PREVOST

WARRANTY BULLETIN

Wb98-09

SUBJECT: PARCEL RACK FAN SPEED CONTROL MODULE

FIGURE 1: PARCEL RACK FAN

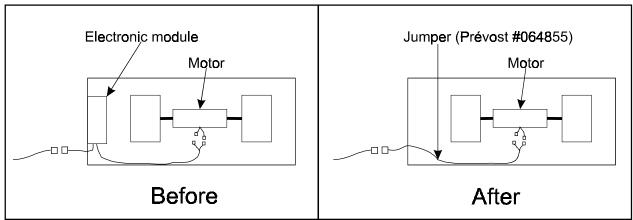
The parcel rack fan speed module proving unstable and difficult to calibrate, a we recommend the installation of jumper to bypass the module.

1. Remove the plastic lens on fluorescent lighting adjacent to blower motor. Start by pulling out the bottom corner of the lens then delicately peeling it out of it's seat;

- 2. Remove air filter to access motor assembly;
- 3. If the parcel rack is an "open" type, remove the right motor cowling;
- 4. Cut the nylon cable tie and disconnect the motor from the electronic control module;
- 5. Disconnect the control module from it's power source then connect the jumper to the now unused power source;
- 6. Remove the electronic control module or cut the wires at the base of the module;
- 7. Pass the jumper through the parcel rack wall;
- 8. Connect the jumper to the blower motor. Be careful to match wire colors;
- 9. Tie down the wire using a cable tie;
- 10. Put the air filter, the plastic lens and the cowling back in place;
- 11. Repeat this procedure on the opposite parcel rack.
